STANDARD REPAIR AND REPLACEMENT

SERVICE BULLETIN NUMBER 1

SERVICE BULLETINS

Spring Shackle Locknuts

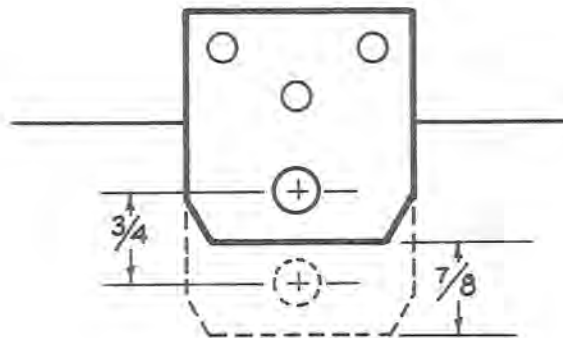
Locknuts on the Spring Shackles will loosen with use if not properly tightened.

Before Snowmobile use, Dealers should verify that Spring Shackle Locknuts are torqued to 40 ft. - lbs.

SERVICE BULLETIN NUMBER 2

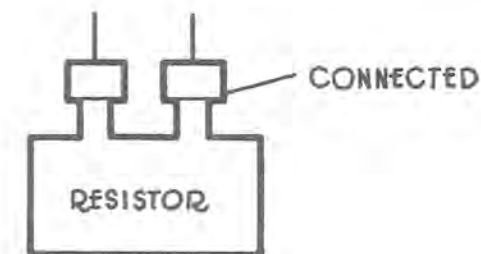
The three Bogie Assemblies may be raised $3/4$ " for added Snowmobile stability. The Bogie hangers should be trimmed off $7/8$ " for added ground clearance if Bogies are raised. A slight loss of climbing ability may be noticed.

Resistor Connected

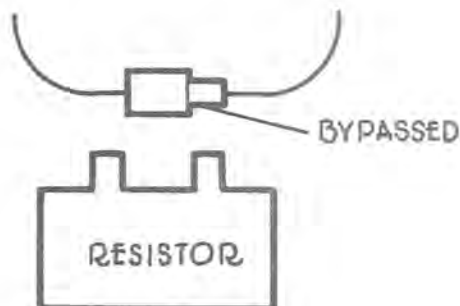
Dim lights on some manual start Firebird Models using GE 44-16 light bulbs can be corrected by bypassing the resistor. The resistor is mounted on the aluminum body forward of the engine. One of the two female terminals must be replaced by a male terminal for ease of connection. The resistor has been removed from later models.

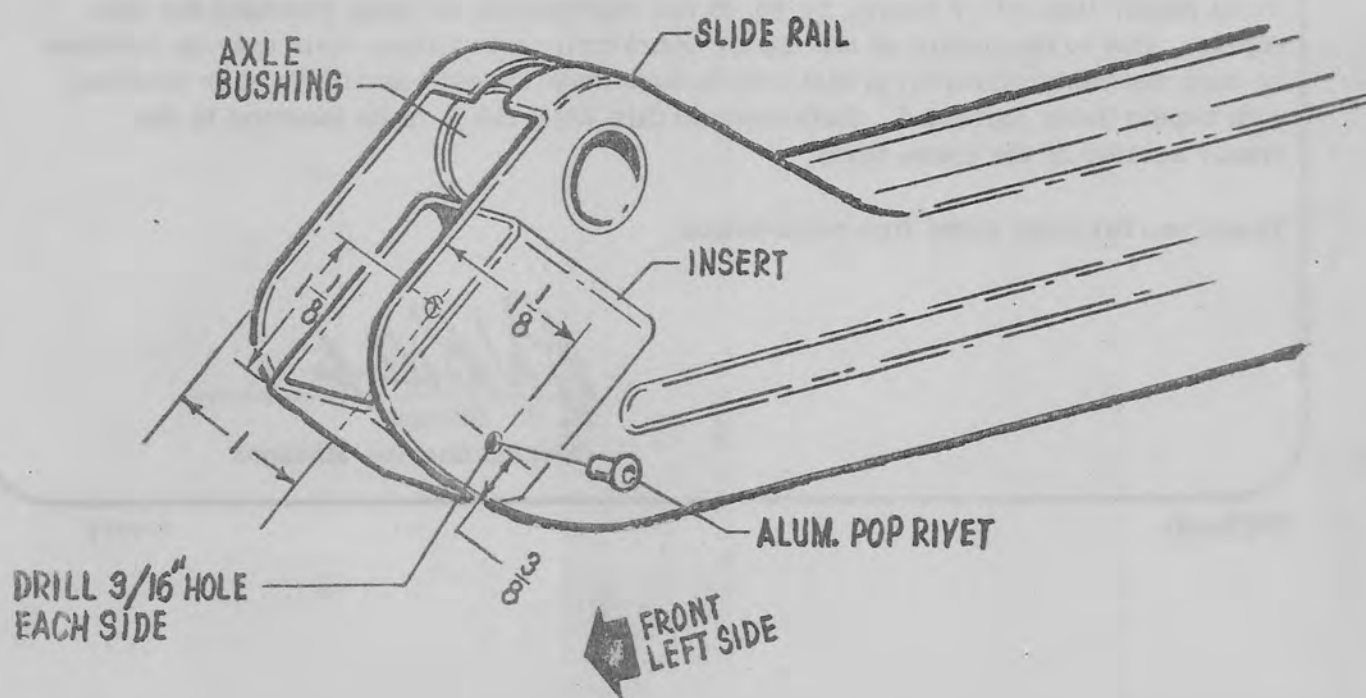
The first three hundred forty Firebirds were produced with rails that had the lower forward section between each channel of the rails extending upwards approximately 3/4" from the bottom horizontal plane of the rail. Due to the Unit Serial numbering sequence, the approximated last serial number is, 100440. Positive identification of rails can be made by looking at one of the later Firebirds or a spare parts rail which has the extended center in each rail. The dimensional difference is readily apparent.

In order to preclude the possibility of any track damage being experienced due to the track flexing in operation causing non-destructive gouging between the drive lugs, rail inserts are being provided direct to each Distributor for forwarding to Dealers having units that need to be modified. Installation details are provided on the reverse side of this Bulletin.

Repair action for slide rail insert:

1. Remove the complete suspension system from the unit by removing four (4) mounting capscrews from the mounting locations.
2. With the slide rail assembly firmly held by one rail in a vise, force the insert into the forward position of the rail as indicated in the sketch.

Note: Be sure the slightly ground corners of the insert are on the exposed side and are to the rear of the rail.

3. The insert should be positioned with a hammer so that the rear or backside of the insert is solid against the steel front axle bushing in the rail.
4. Hold the insert firm by clamping with a pair of vise grips on the outside forward edge of the rail.
5. Center punch and drill one 3/16" hole through each side of each rail per the sketch.
6. One aluminum pop rivet with "1/4 inch grip" in each hole is to be used to permanently fasten the insert. Remove vise grips.
7. Reinstall the assembly.
8. Adjust track alignment and tension.
